Office Action Summary

09/847,759

Gregory J. Strimbu

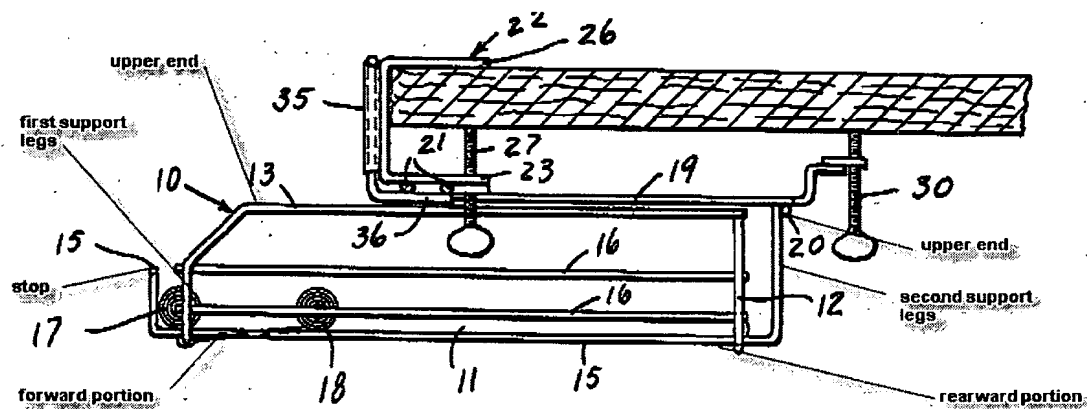
Claims 20, 22-24, 26, 28, 29, 30, 32, 35, 36, 39, 49-52 and 63-67 are rejected under 35 U.S.C. 103(a) as being unpatentable over Dickson in view of Lockwood. Dickson discloses a rack 10 comprising a support assembly 15 having a forward portion (labeled below) and a rearward portion (labeled below) and being configured to support a plurality of beverage containers; a first pair of support legs (labeled below) having lower ends connected to the forward portion; and a second pair of support legs (labeled below) having lower ends connected to the rearward portion, each of the first and second pairs of support legs having upper ends (labeled below) configured to hang the rack from a shelf disposed above the rack; a spacing defined between the upper ends of the second pair of support legs and the rearward portion of the support assembly sized so as to allow beverage containers to be inserted between a rear portion of the shelf and the rearward portion of the support assembly; a stop (labeled below) disposed at the forward portion of the support assembly, wherein the first and second pairs of support legs are sized, i.e., the second pair of support legs are longer than the first pair of support legs, such that the forward portion hangs lower than the rearward portion when the rack is hanging, by the upper ends of the first and second pairs of the support legs, from a horizontal shelf. It should be noted that the rack 10 of Dickson, although not shown, is capable of hanging with the front portion lower than the rear portion by

merely adjusting the threaded fastener 30 (see column 2, lines 42-46); threaded fasteners 27 connecting the upper ends of the first and second pairs of support legs to the shelf; wherein the support assembly is configured to support a plurality of parallel files of beverage containers extending between the rearward portion and the forward portion; wherein the support assembly comprises a wire frame configured to allow cylindrical beverage containers to roll along an upper surface thereof; a plurality of supports 21, 23 configured with sufficient strength to support additional shelving above the beverage containers supported on the first surface; the plurality of supports comprise at least two rod members; apertures (not numbered, but shown where the fasteners 27 penetrate the supports 23). Dickson is silent concerning a panel.

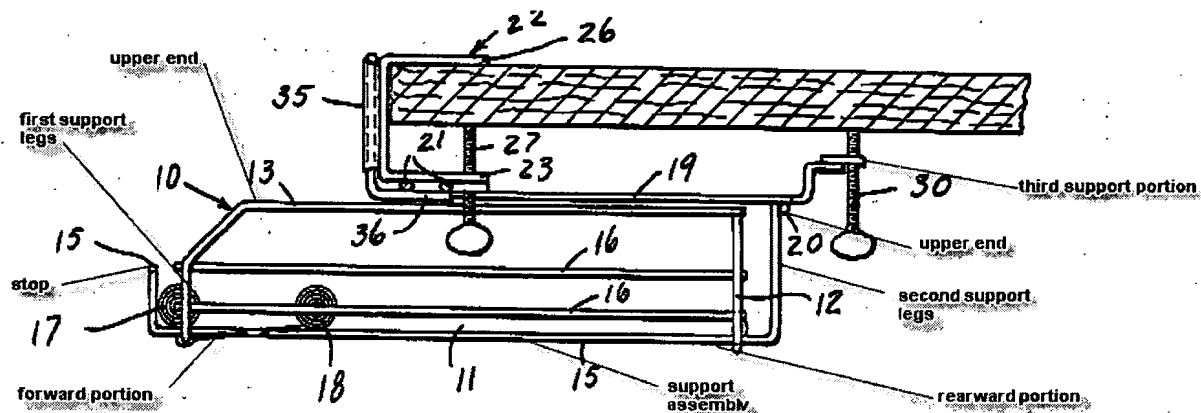
Claims 57-59 are rejected under 35 U.S.C. 103(a) as being unpatentable over Dickson in view of Lockwood. Dickson discloses a shelf 10 comprising: a support assembly (labeled below) having a forward portion (labeled below) and a rearward portion (labeled below), the support assembly defining a support surface configured to support a plurality of cylindrical beverage containers; a stop (labeled below) disposed at the forward portion of the support assembly; first and second support portions 22 disposed at the forward portion of the support assembly, the first and second support portions including upper ends, respectively, disposed above the plurality of cylindrical beverage containers supported on the support surface; at least first and second apertures (not numbered, but comprising the apertures through which the fasteners 27 extend) disposed adjacent the upper ends of the first and second support portions, respectively, the first and second apertures being configured to receive fasteners 27 for supporting the forward portion of the support assembly from a shelf 32 above the support assembly, the first and second apertures being spaced rearwardly from the stop; a third support portion (labeled below) disposed at the rearward portion of the support assembly, the third support portion including an upper end (not numbered, but

shown in figure 3); and at least a third aperture (not numbered, but comprising the aperture through which the fastener 30 extends) disposed adjacent the upper end of the third support portion, the third aperture being configured to receive a fastener 30 for supporting the rearward portion of the support assembly from a shelf above the support assembly; wherein the third aperture is spaced from a rearward-most portion of the rearward portion of the support assembly such that cylindrical beverage containers can be placed onto the rearward portion of the support assembly when the third aperture is connected to a shelf 32 disposed above the support assembly by fasteners. Dickson is silent concerning a panel configured to support a label and a fourth support portion.
